## **Addendum 109: Regulation No. 110**

### **Revision 1 – Amendment 2**

- I. Specific components of motor vehicles using compressed natural gas (CNG) in their propulsion system;**
- II. Vehicles with regard to the installation of specific components of an approved type for the use of compressed natural gas (CNG) in their propulsion system**

“Figure 2  
 20 MPa Filling unit Size 2 (receptacle) for M<sub>2</sub>, M<sub>3</sub>, N<sub>2</sub> and N<sub>3</sub> vehicles

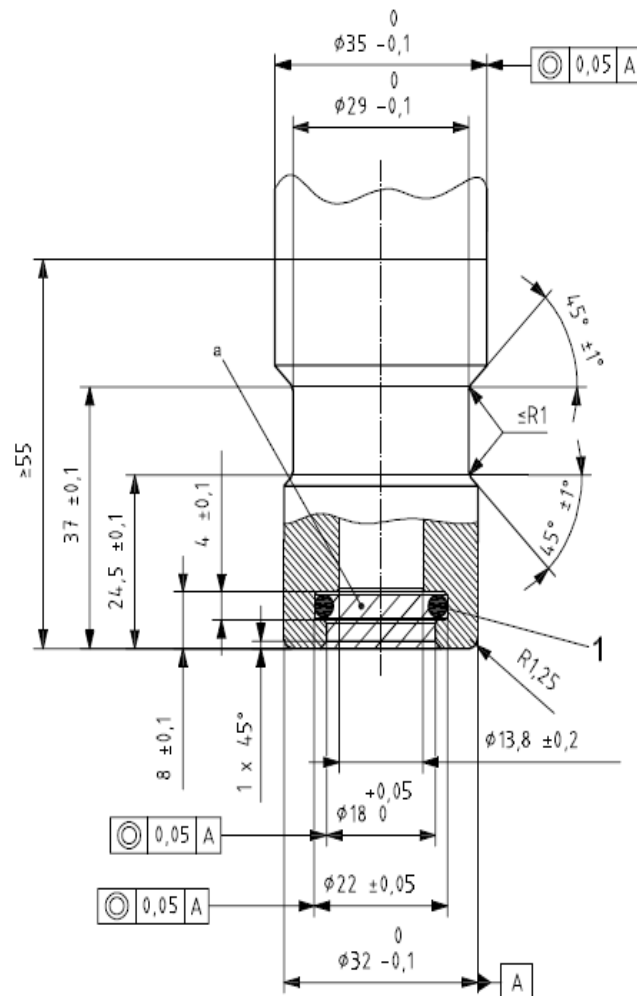
*Insert a new paragraph 4.2., to read:*

“4.2. Figure 2 shows the dimensions of the filling unit for vehicles of categories M<sub>2</sub>, M<sub>3</sub>, N<sub>2</sub> and N<sub>3</sub><sup>3</sup>”

Insert, after Figure 1, a new Figure 2, to read:

1 sealing ID =  $\varnothing 15,47 \pm 0,1$  width =  $\varnothing 3,53 \pm 0,2$

<sup>a</sup> This area shall be kept free of all components

Surface roughness < Ra 3,2  $\mu\text{m}$ .

Sealing surface finish: 0,8  $\mu\text{m}$  to 0,05  $\mu\text{m}$ .

Material hardness: 75 Rockwell B (HRB 75) minimum.
